ADDENDUM NO. 02

Oak Hill United School Corporation – Multi-School MEP Improvements
405 South Washington St, Swayzee, IN 46986
7760 Delphi Pike, Converse, IN 46919
600 Walnut St, Converse, IN 46919

ADDENDUM TWO

Addendum Two (AD.02) to the drawings and specifications prepared by Gibraltar Design for **Mechanical Improvements Across Three Schools** for Oak Hill United School Corporation Converse, Indiana.

ED102

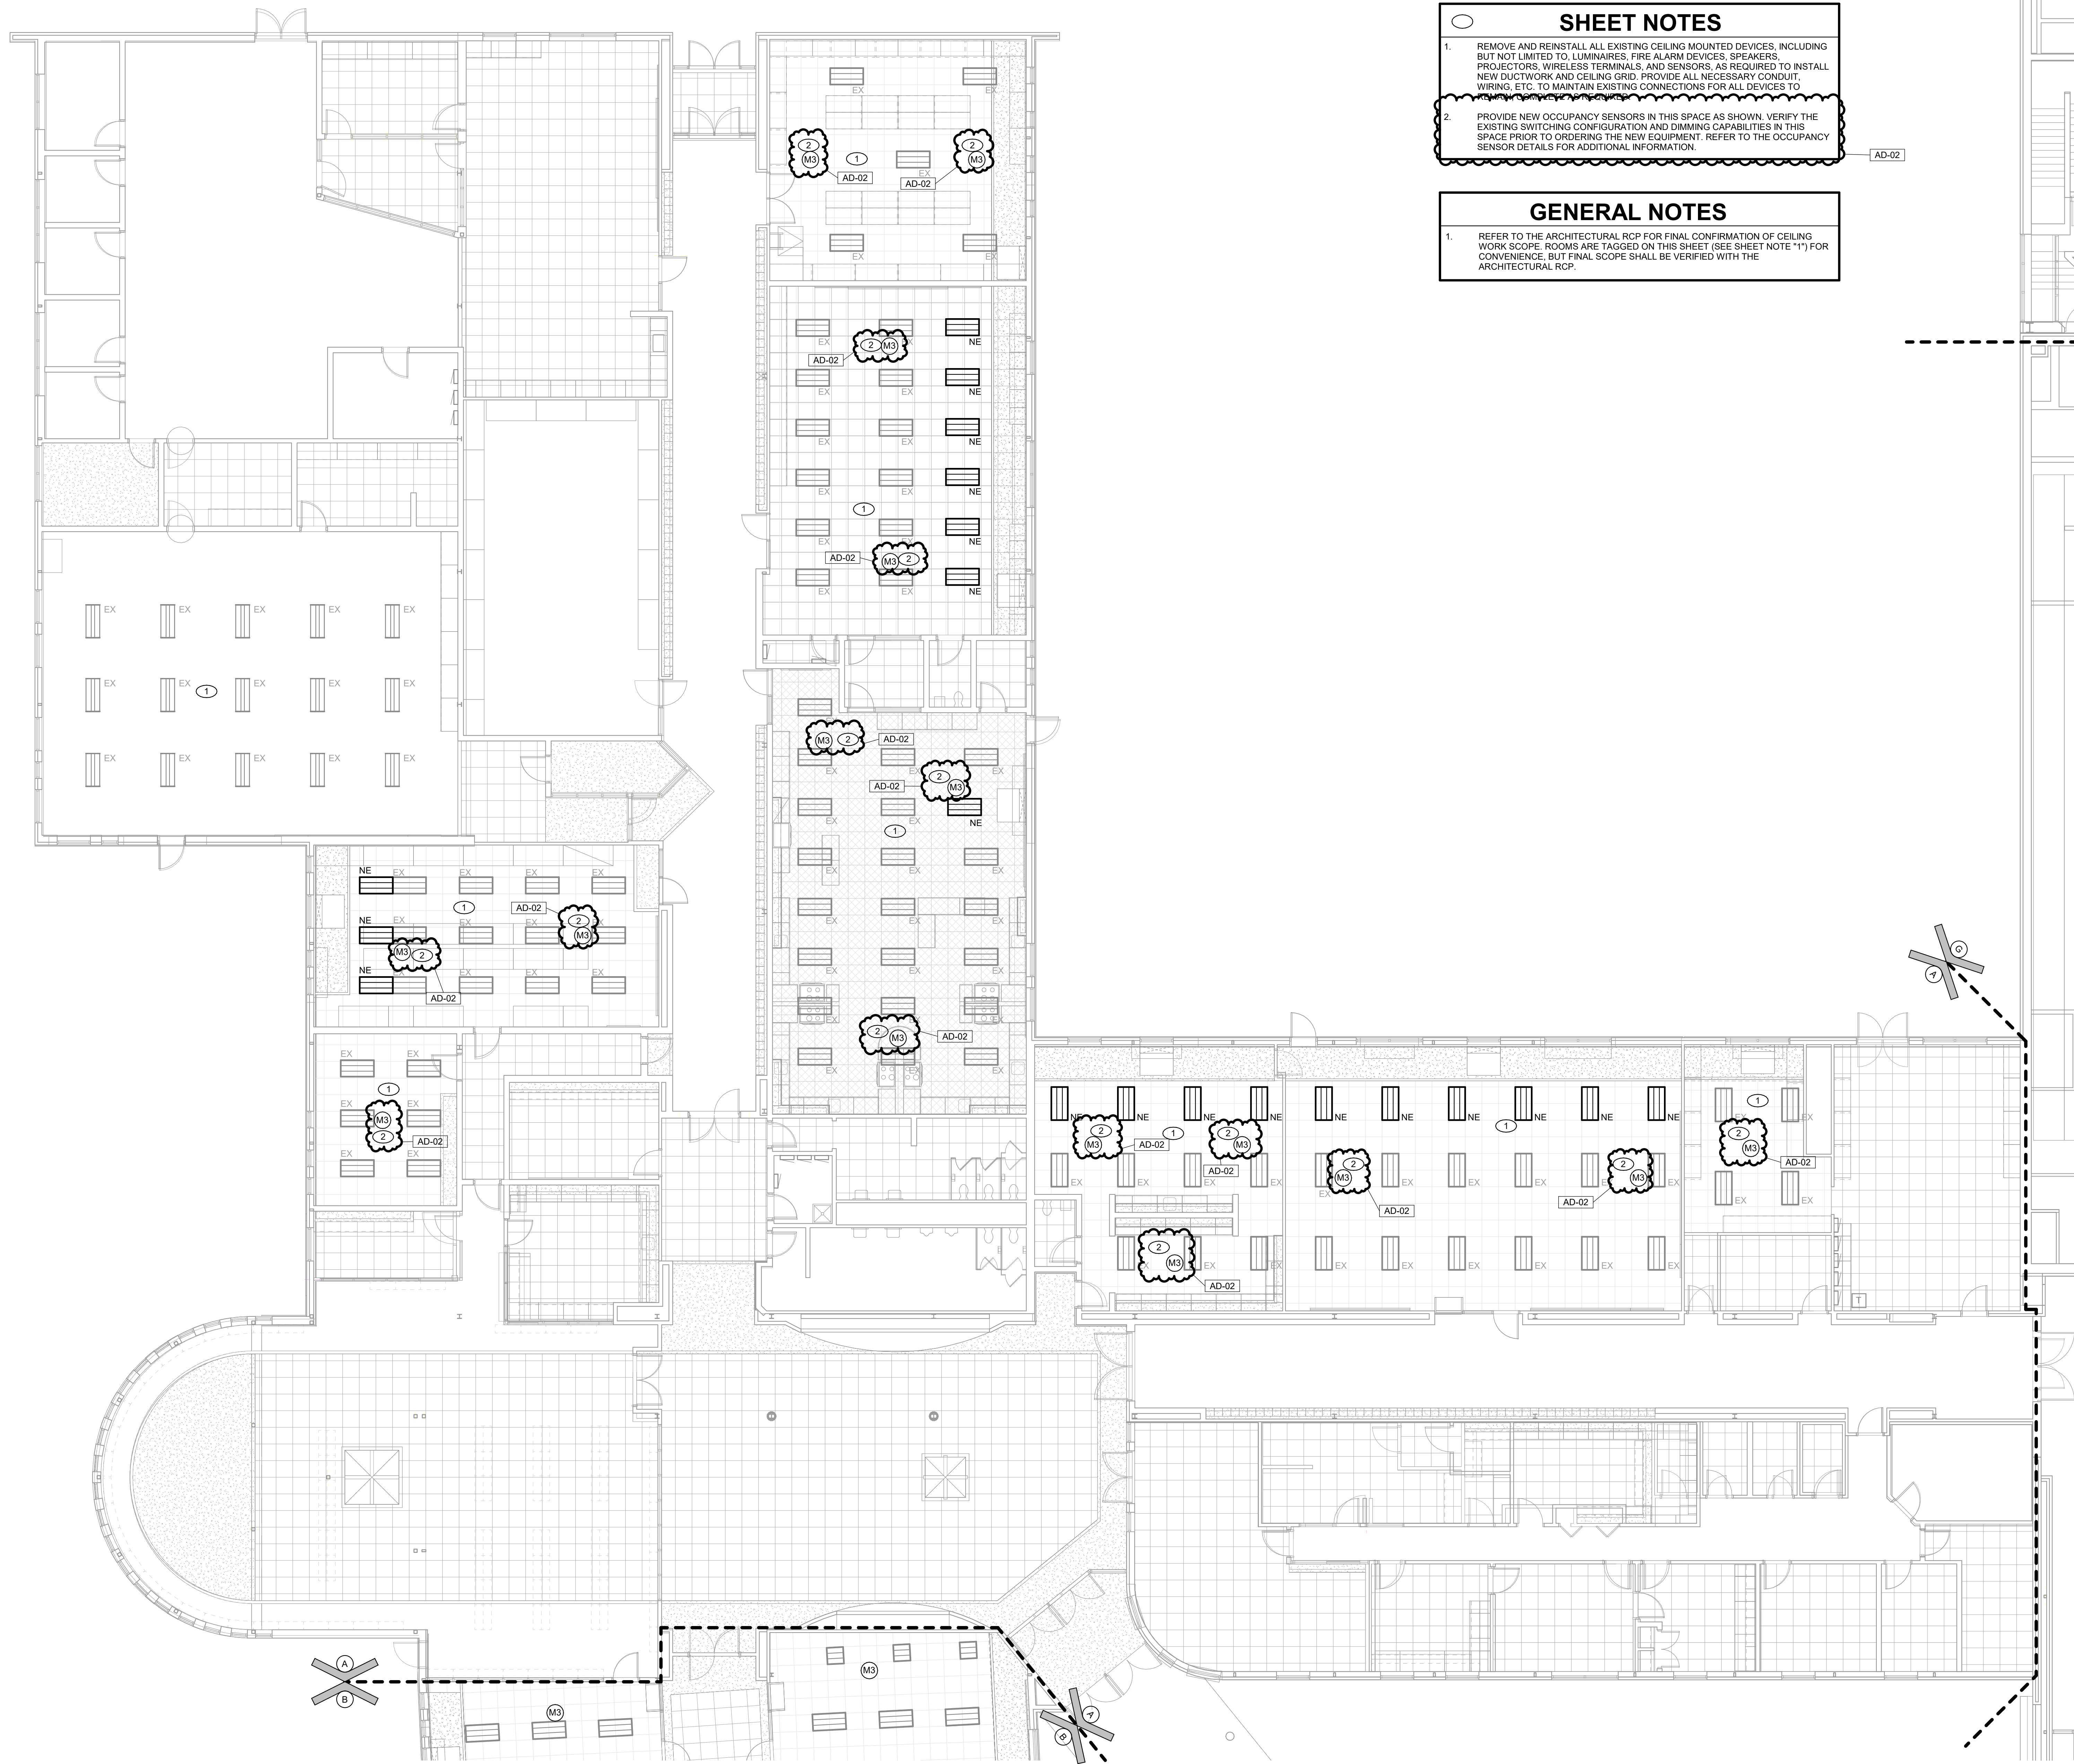
9. Sheet ED102

1. Revised occupancy sensor phasing.

EL101

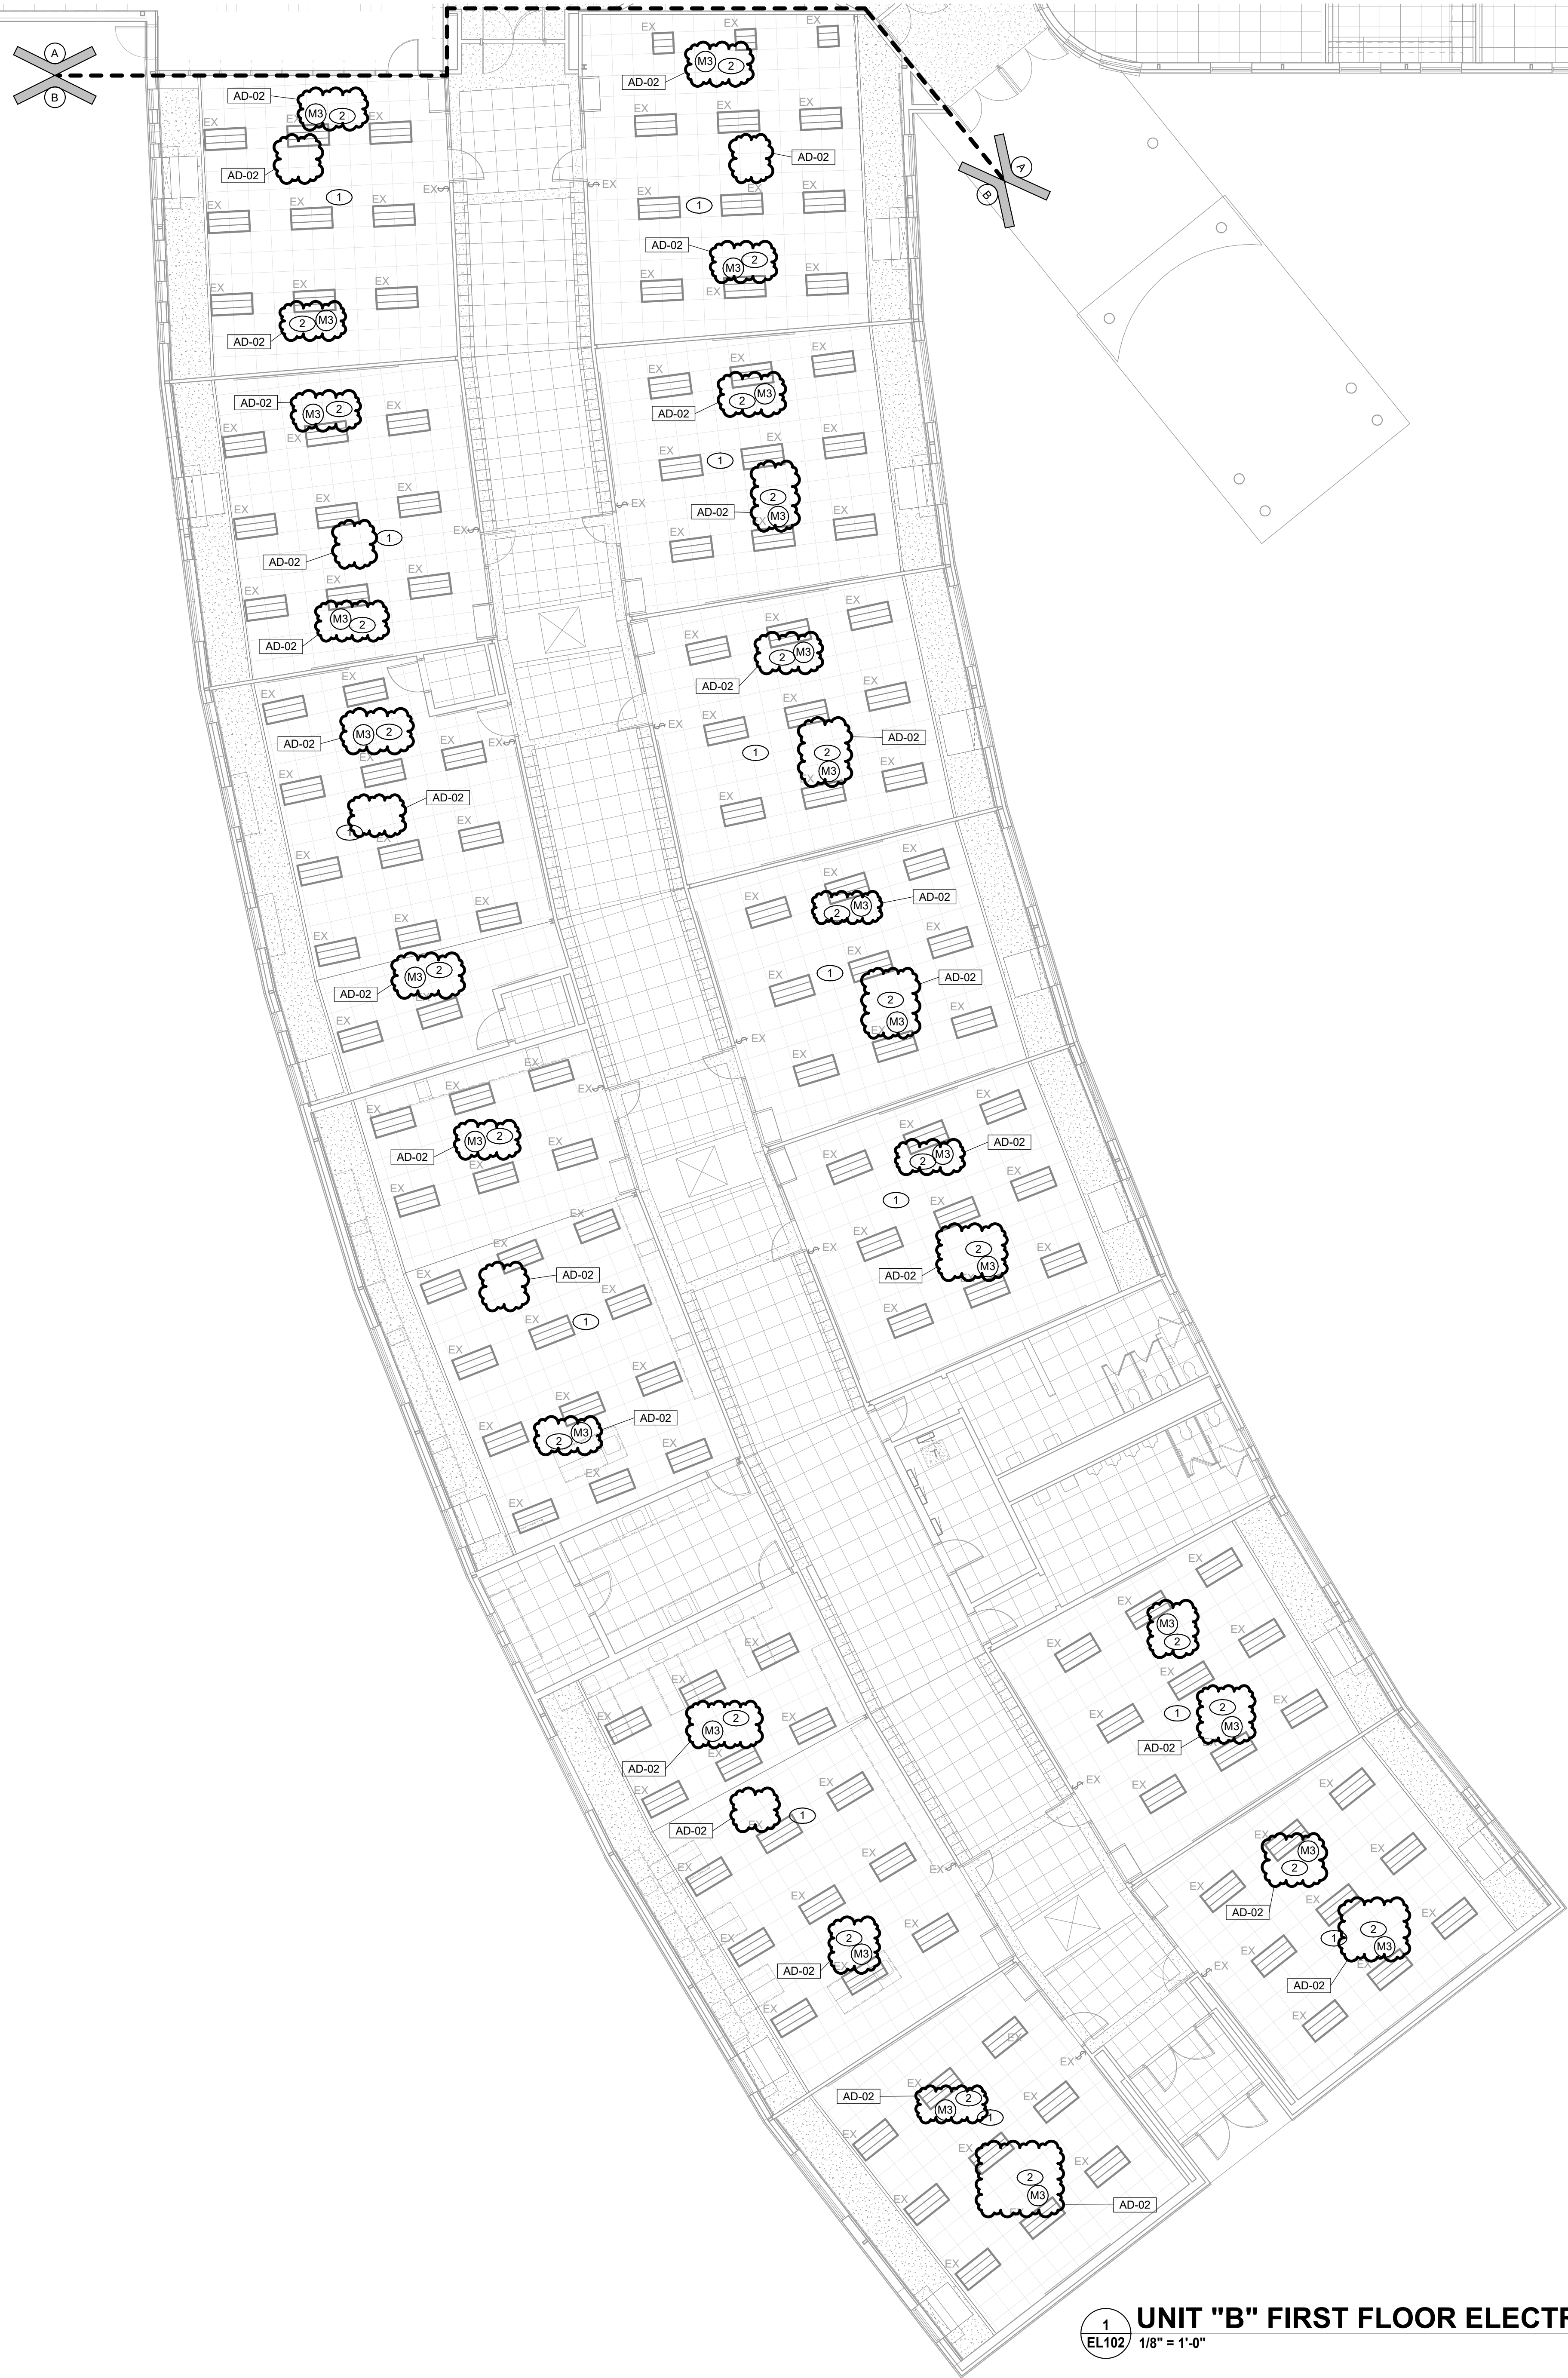
10. Sheet EL101

1. Added Sheet Note #2.
2. Added and revised occupancy sensors and occupancy sensor layout.
